PICKUP - 6.7L DIESEL ENGINE - RUNS ROUGH/MISFIRE DURING EXHAUST REGENERATION PROCESS	TSB 15-0124
---	--------------------

2011-2014 F-250, F-350, F-450

This article supersedes TSB 13-9-15 to update the vehicle model years, vehicle line application and Service Procedure.

Figure 1 - Article 15-0124

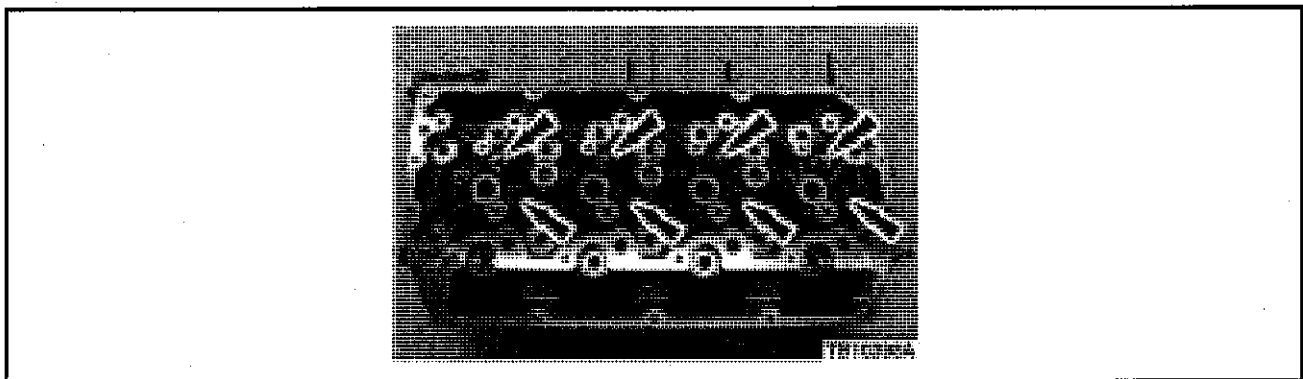
Some 2011-2014 F-Super Duty pickup truck vehicles equipped with a 6.7L diesel engine may exhibit a runs rough/misfire condition only during the exhaust regeneration process. This condition typically occurs on light throttle tip in between 64-113 Km/h (40-70 MPH), and will not set diagnostic trouble codes (DTCs). The concern may be intermittent and a knocking noise may be present during the concern.

1. Did the customer indicate the message center displayed a Cleaning Exhaust Filter message prior to the concern?
 - a. Yes - proceed to Step 2.
 - b. No - this article does not apply. Refer to the Powertrain Control/Emissions Diagnosis (PC/ED) Manual for normal diagnosis.
2. Using Integrated Diagnostic System (IDS) or equivalent, retrieve DTCs from the powertrain control module (PCM). Are DTCs present?
 - a. Yes - this article does not apply. Refer to the PC/ED Manual for normal diagnosis.
 - b. No - proceed to Step 3.
3. Remove the left cylinder head. Refer to Workshop Manual (WSM), Section 303-01.
4. Replace all eight (8) exhaust valves and valve seals. Refer to WSM, Section 303-01. (Figure 1)
